Maxtor Corporation
500 McCarthy Boulevard
Milpitas, CA 95035 USA

To: T10 SAS Protocol Working Group
Contact: Mark Evans
Phone: 408-894-5310
Email: mark_evans@maxtor.com
Date: 30 August 2004

Subject: SAS-1.1, ST_I (transport layer for SSP initiator ports) state machines

Figure 1 — ST_I (transport layer for SSP initiator ports) state machines

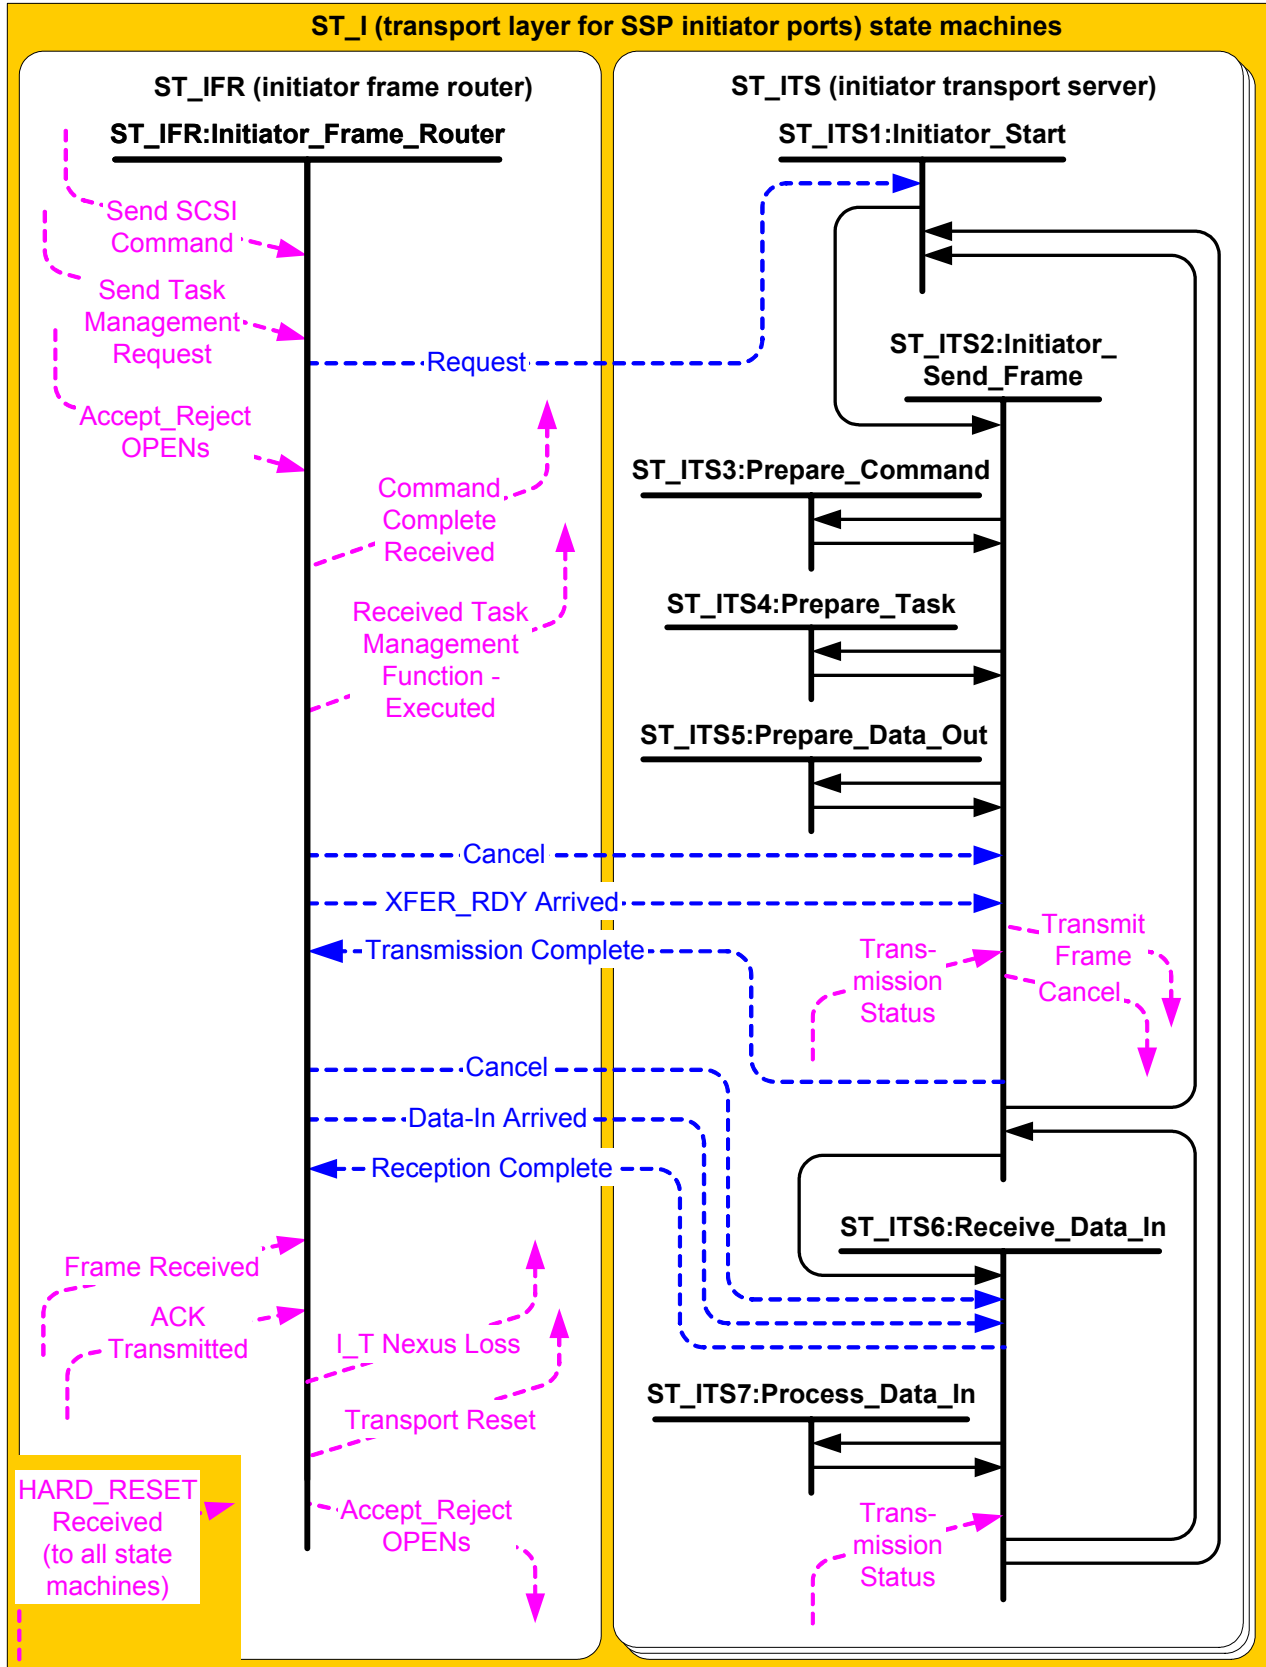
This proposal evolved from adding transport layer retries and the new protocol service, Terminate Data Transfer, to the SSP transport layer state machines. While including these elements, changes were made to simplify and clarify the description of these state machines. These changes include having all communication with the initiator's SCSI application layer be processed by the initiator frame router state machine, having a virtual initiator transport server state machine for each tag, and having the initiator transport server state machines be persistent between power cycles.

Having all communication with the SCSI application layer be processed by the initiator frame router state machine provides the ability for that state machine to maintain context for all tasks in process so that it can abort tasks as necessary. Having initiator transport servers for each tag provides the ability for one state machine to maintain context to process all elements of a task (e.g., COMMAND frame transmission, XFER_RDY reception, and data transfer). Having the initiator transport server state machines be persistent between power cycles simplified their description.

The attempt was made to have the description of the initiator transport layer state machines be as consistent as possible with the target transport layer state machines (see 04-137). This proposal is based on SAS1r05.

Figure 1 shows the ST_I state machines.
